Subject: Zoning By-law Amendment – 1081 Carling Avenue

File Number: ACS2023-PRE-PS-0075

Report to Planning and Housing Committee on 16 August 2023

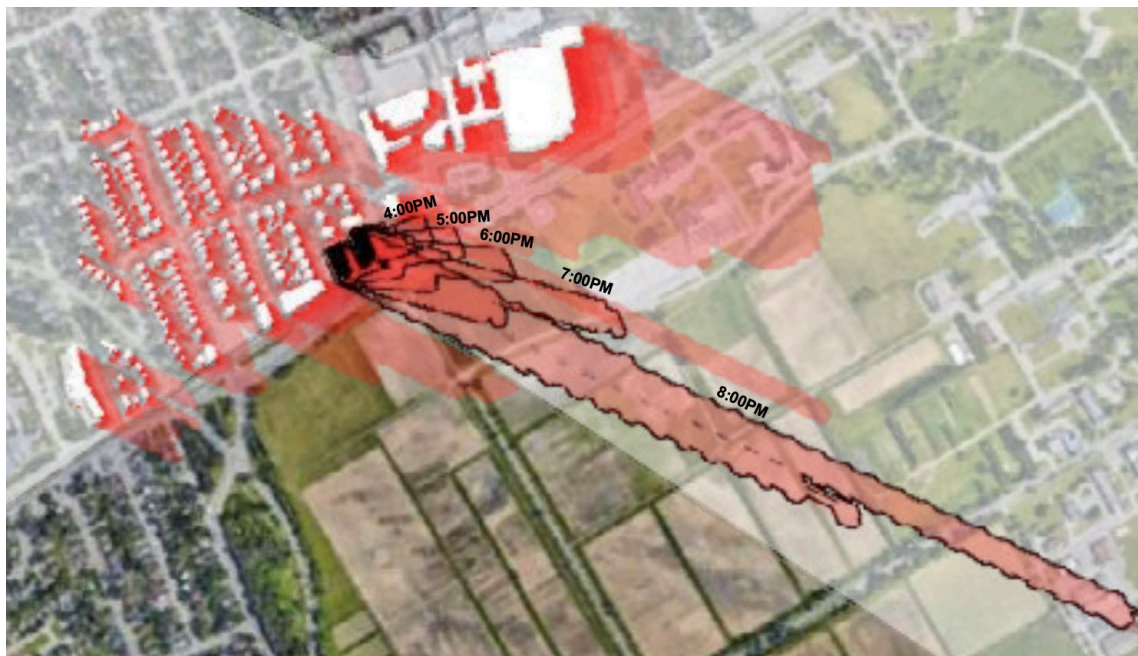
I’ve shown here a detail from the proposed site plan. The configuration would see, from the north, the nearest R1QQ property, a 4.9 metre-wide City-owned laneway, a 13.5 metre-deep parkland dedication and a 3.3 metres-deep setback from the podium to the boundary with the park. In all, there is a roughly 21.7 metre setback from the southern edge of the adjacent low-rise to the east tower’s podium. This is, by any measure, a

The problem arises as the tower is stepped back just 3.2 metres from the podium for levels 5-9 before levels 10-27 rise up without stepback, albeit with a reasonably generous 7 metres stepback from the levels below it.

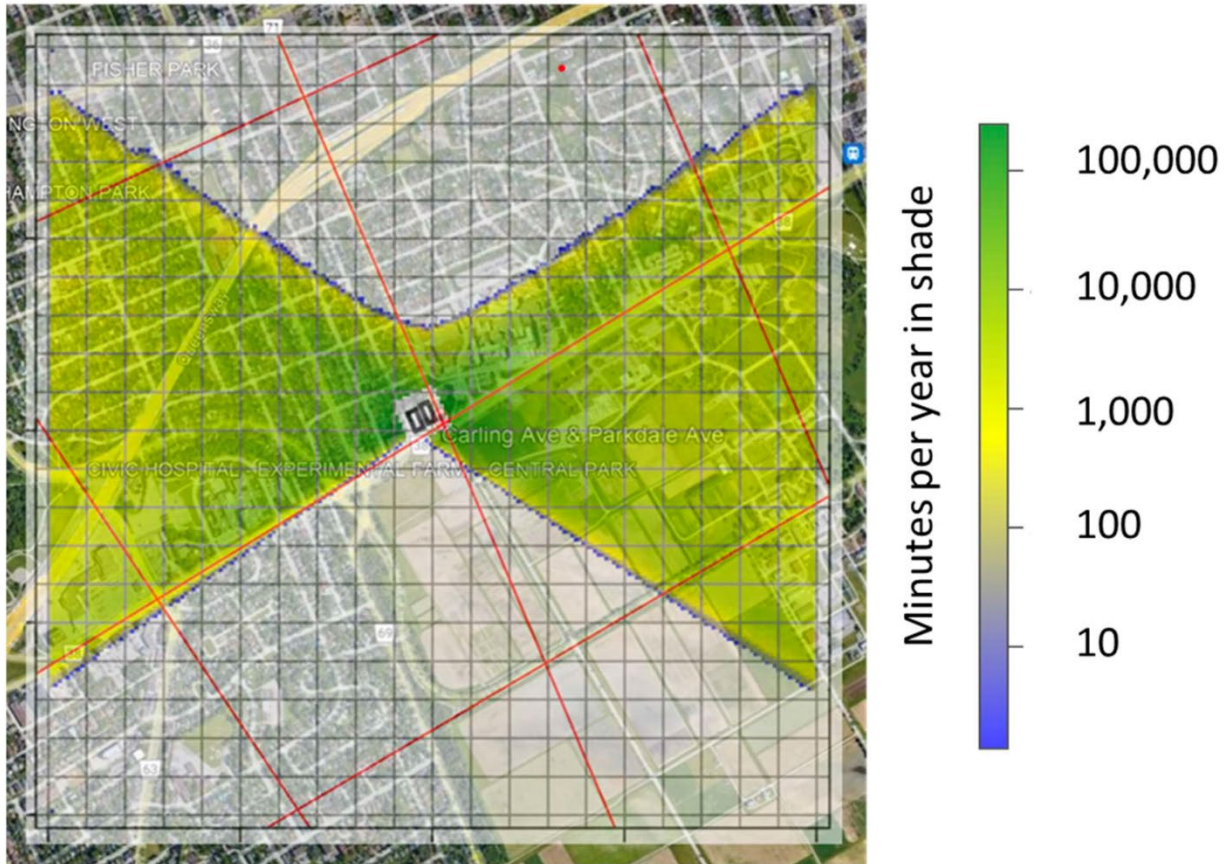
I've spent some significant time speaking with the scientists and they have a real concern. Below, I've pasted a screen shot of the shadow study provided by the developer to show that in the later evening, a long shadow will move across several fields in which there is an ongoing experiment testing approaches to assisting bacteria to better help soybean plants fix nitrogen in sandier, dryer soils. I have also pasted a screen shot showing modeling by Agriculture Canada demonstrating the reduced minutes of sunlight (including red spectrum light that is particularly important to the process of photosynthesis and that is more abundant when the sun is at a more oblique angle later in the day: it is helpful to know that there are 260,000 minutes of sunlight in an Ottawa growing season, not accounting for cloudy days).
